COUNCIL SUPPLEMENTARY REPORT

Panel Reference	2017SNH012
Application Number	LDA2016/0395
LGA	City of Ryde
Proposed Development	Construction of a mixed use development
Street Address	25 - 27 Epping Road, Macquarie Park (Lachlan's Line)
Applicant/Owner	Greenland (Sydney) Lachlan's Line Macquarie Park Development Pty Ltd
Date of Lodgement	1 July 2016
Recommendation	Rejection of the amended proposal and the approval of the proposal originally presented to the Panel on 9 August 2017
List of all documents submitted with this report for the Panel's consideration	<p><u>Appendix A</u> Assessment Report</p> <p><u>Appendix B</u> Supplementary Report (27 September 2017)</p> <p><u>Appendix C</u> Draft Conditions</p> <p><u>Appendix D</u> Addendum to the Statement of Environmental Effects from Urbis and attachments:</p> <ul style="list-style-type: none"> • Attachment A: SNPP Record of Deferral; • Attachment B: Clause 4.6 Request – Height of Buildings; • Attachment C: Clause 4.6 Request – Floor Space Ratio; • Attachment D: Solar Access Options Study; • Attachment E: Lot 104 Amended Architectural Drawings; • Attachment F: Lot 105 Amended Architectural Drawings; • Attachment G: Design Verification S

Figure 2: View of amendments to Buildings L3 and M on Lot 104.

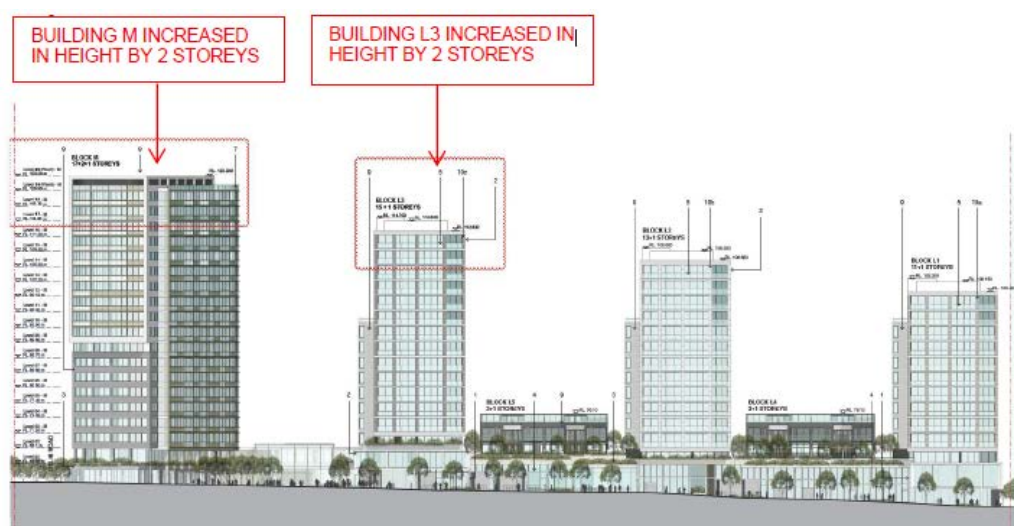
Figures 2 and 3 below show the amendments proposed to the development when viewed from Jarvis Circuit:

The amended proposal seeks approval of a variation of 10.8% (i.e. 6.2m) to the Height of Buildings Development Standard. The non-compliance is located on Building M and comprises one (1) storey and the lift overrun.

Figure 6: Overshadowing (additional shadow is indicated in red) on 21 June (mid-winter).

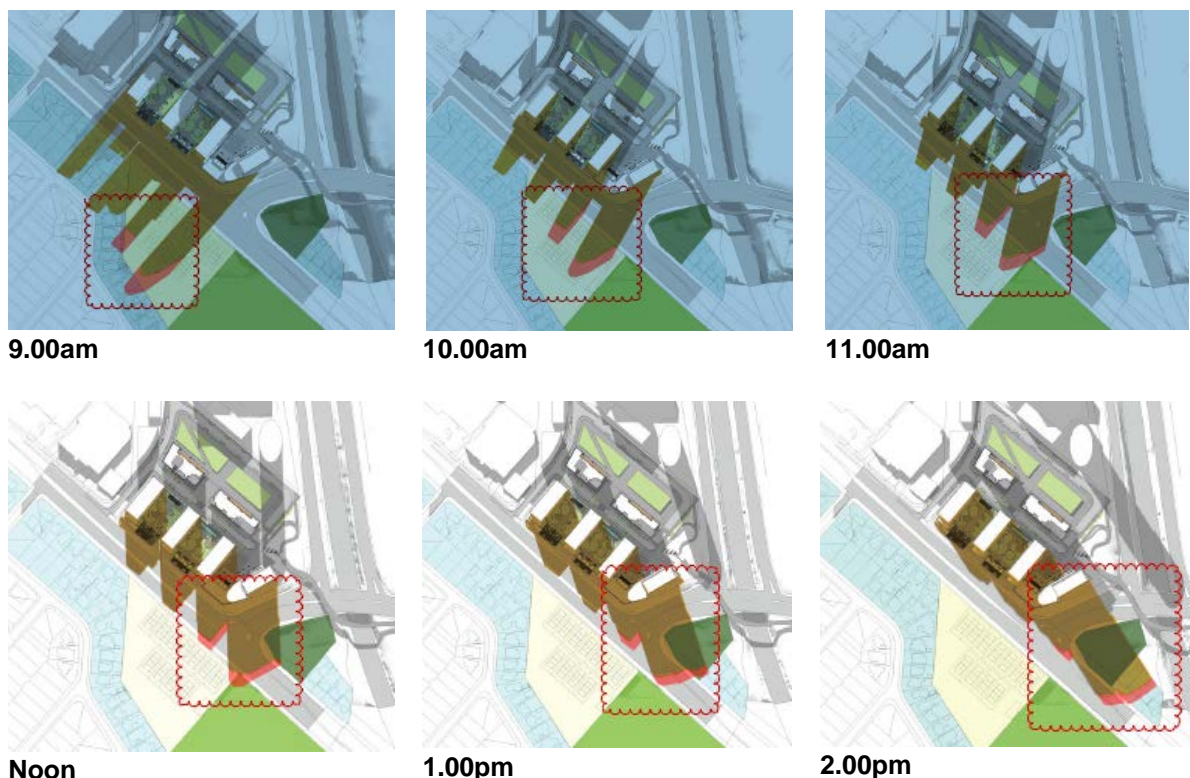
The shadow diagrams provided with the amended proposal (see Figure 4 below) indicate that additional overshadowing will occur over residential properties along Morshead Street to the south-west and over Bundara Reserve to the south-east.

Notwithstanding the overshadowing provision of Clause 5.6(5) of the *North Ryde Station Precinct Development Control Plan 2013* which requires that “no overshadowing of residential lots outside of the Precinct is to occur after 11 am on June 21”, the amended proposal is not considered to minimise overshadowing or minimise the impact of development on the amenity of surrounding properties as required by the Objectives of the Height of Buildings Development Standard pursuant to Clause 4.3 of the RLEP 2014.

Therefore, the requested variation to the Development Standard is not supported because of the additional impact resulting from the proposed height of the development and its commensurate building bulk.

Figure 6 below shows the extent of additional shadow cast as a result of the amended proposal (the darker blue strip of land indicated in the 9.00am image is the residential area aligning Morshead Street).
